SERVICE BULLETIN

Classification: MT97-001	Reference: NTB97-011	Date: January 29, 1997
-----------------------------	-------------------------	---------------------------

FS5R30A AND RS5R30A TRANSMISSIONS DETENT HOLES ELIMINATED FROM ADAPTER PLATE

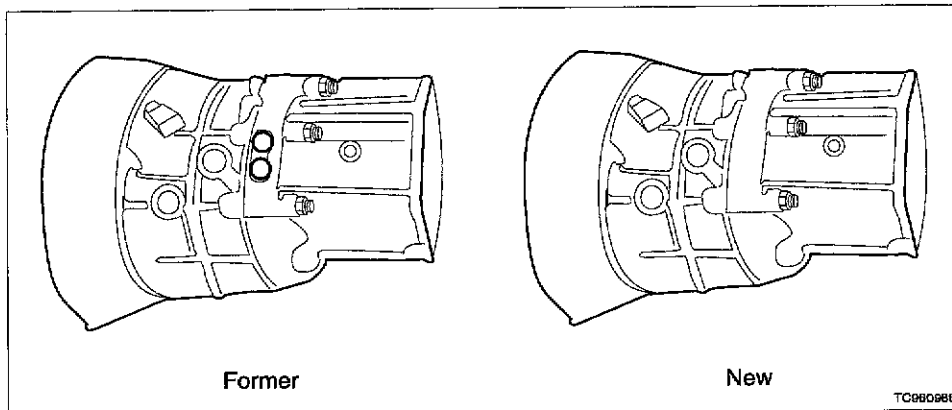
A new adapter plate has been implemented on the FS5R30A and RS5R30A transmissions. There are no detent holes or related components (check ball, spring and bolt) on the new adapter plate.

The function of the detent hole and its related components was to prevent the reverse shift fork from breaking. Beginning July 10, 1986, the reverse shift fork material was changed eliminating the need for the detent hole and the detent related components.

Except for the 1986.5 Truck, the new adapter plate can be used as a full replacement on all FS5R30A and RS5R30A transmissions. **Discard the original set of detent components from the adapter plate being replaced.**

For the 1986.5 Truck, **in addition to the new adapter plate replacement**, you must install a new reverse shift fork, P/N 32819-01G60.
